TXX-2941

January 31, 1979

COMANCHE PEAK STEAM ELECTRIC STATION  
NRC ROUND ONE HYDROLOGY QUESTIONS  
DOCKET NOS. 50-445 & 50-446  
FILE NO. 10010

COMANCHE PEAK S E S NUCLEAR PLANT UNITS 1 and 2
FLOW IN SPILLWAY DISCHARGE CHANNEL
FIGURE 371.4

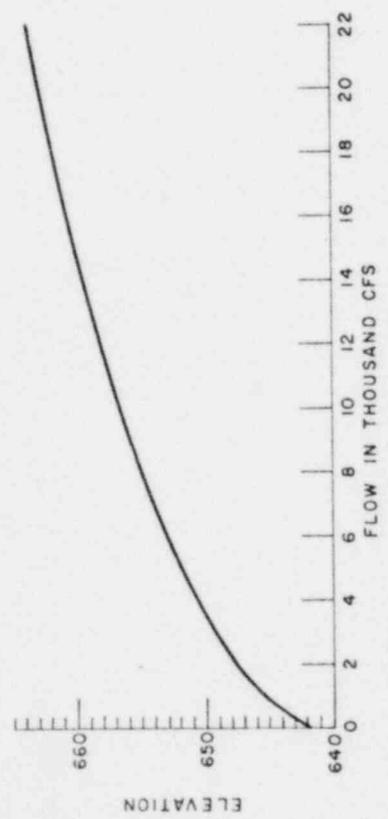
- (6) Define the location and length of the hydraulic jump in the stilling basin and assure that the side walls are of sufficient height to contain this jump.
- (7) Provide a tailwater rating curve and a water surface profile in the spillway discharge channel. Discuss the computational technique used to derive this profile.

- (7) The tailwater rating curve for the stilling basin design and the water surface profile in the spillway discharge channel during the probable maximum flood are shown in Figure 371.4. The tailwater rating curve for the spillway was obtained from a backwater analysis of the flow in the spillway discharge channel. The Corps of Engineers' HEC II computer program was used for the analysis. A Manning's n of 0.030 was used for the channel. The water surface elevation at the downstream end of the discharge channel was obtained from a backwater analysis of the existing conditions on Squaw Creek. Studies showed

that the tailwater rating curve was not sensitive to water levels at the downstream end of the discharge channel.
